MEMORANDUM

From: Planning Control Manager **To:** Head of Environment and Planning
Our Ref: EP/DC/PP/2018/0608 **Your Ref:** SEH/P/2018/0608
Date: 21st February 2019

Location: O. S Grid Ref: 417 395 Big Green Farm, Ellesmere Lane, Penley, Wrexham.
Development: Application for Approval of Reserved Matters Pursuant to Appeal
Ref: APP/H6955/A/17/3186707 (Appearance, Landscaping, Layout, Scale) for Residential
Development Comprising 13 Houses.

I refer to your consultation / email dated 20/02/2019 including revised layout plan (Drg. No. 6670-10 rev B) in respect of the above.

Scale 1:200

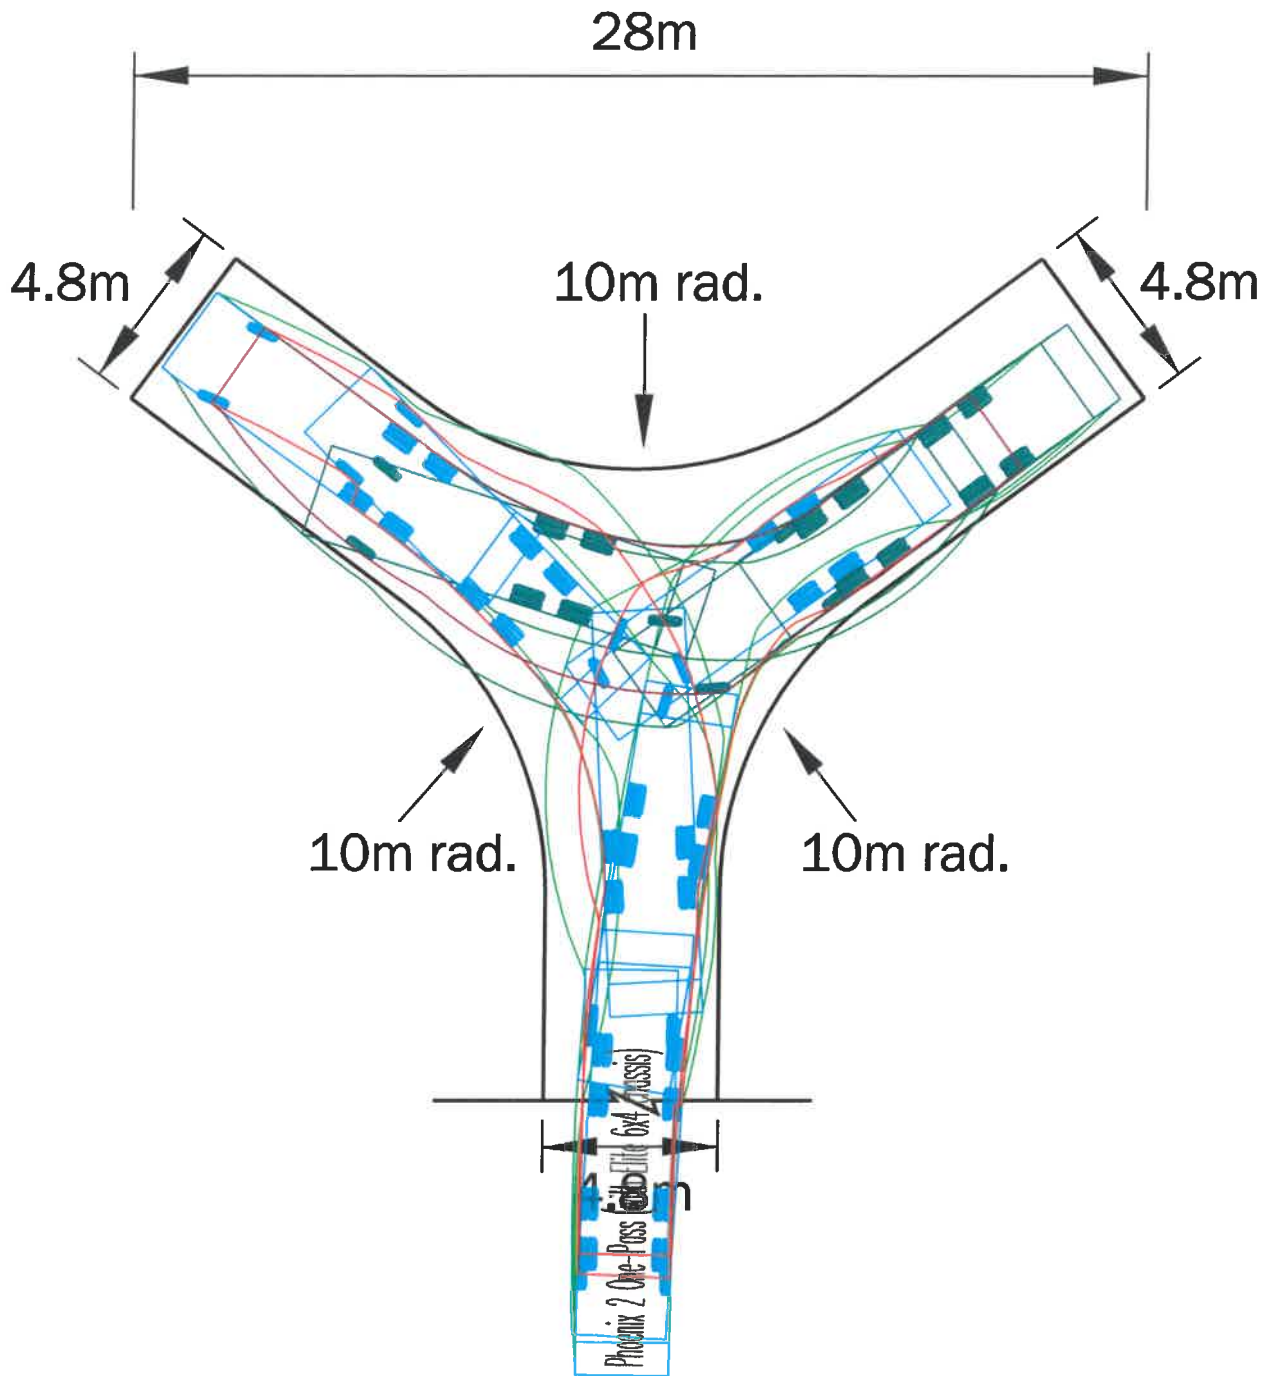
The proposed turning head indicated on the revised layout plan does not comply with our adoptable standards (see attached detail). The attached swept paths indicate that there is a slight overhang of the refuse vehicle when maneuvering within the turning head. The areas of overhang are likely to be impeded by the proposed shrub planting indicated on the revised layout plan. However, provided that these affected areas can be kept clear of any planting / obstructions then the turning head could be considered acceptable. **I would recommend that the applicant indicates this detail on a revised layout plan.** The proposed turning head will need to be surfaced with standard construction materials ie/ bitmac (to WCBC adoptable standards).
